Docket # 2025 NON

**RE: PacifiCorp's Response to Notice of Non-Performance –  
PAD\_PC\_CYA\_20251007\_0930**

**Picture 1: Near Pole ID 06245007.0275104, Grid Hardening ID 7074439 at coordinates 41.71645204223936, -122.6414627790075. Picture taken February 5, 2026.**

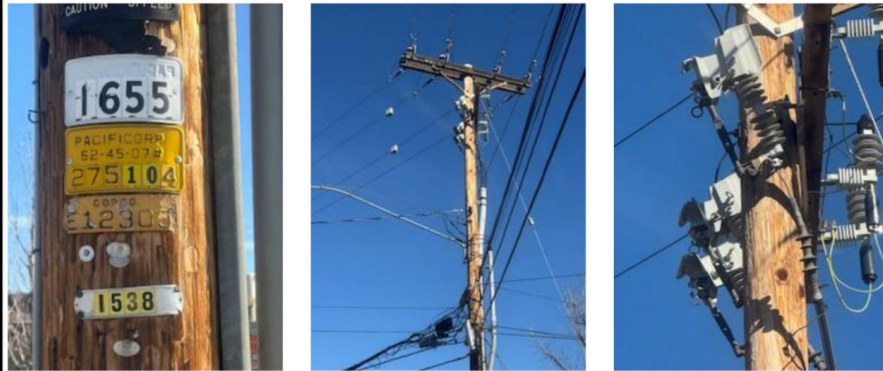
**Deficiency 1.** Energy Safety observed that in implementing 2025 WMP initiative 8.1.2.12 - Expulsion Fuse Replacements, PC failed to complete the installation of CAL FIRE-approved non expulsion fuses on Pole ID 06245007.0275104, Grid Hardening ID 7074439 at coordinates 41.71645204223936, -122.6414627790075. Energy Safety considers this non-performance to be in the Minor risk category. PC must complete a corrective action for this deficiency by 12 months from this date of notice.

In response to the Notice of Non-Performance, the company conducted a field inspection on February 5, 2026. No corrective actions were required. Solid blades were previously installed at this location. Although Pacific Power reported these installations as complete in 2024, CAL FIRE has not yet updated its standards to classify solid blades as non-exempt for line fuses. As a result, Pacific Power has discontinued counting similar installations as completed units; however, the solid blades already installed will remain in place.
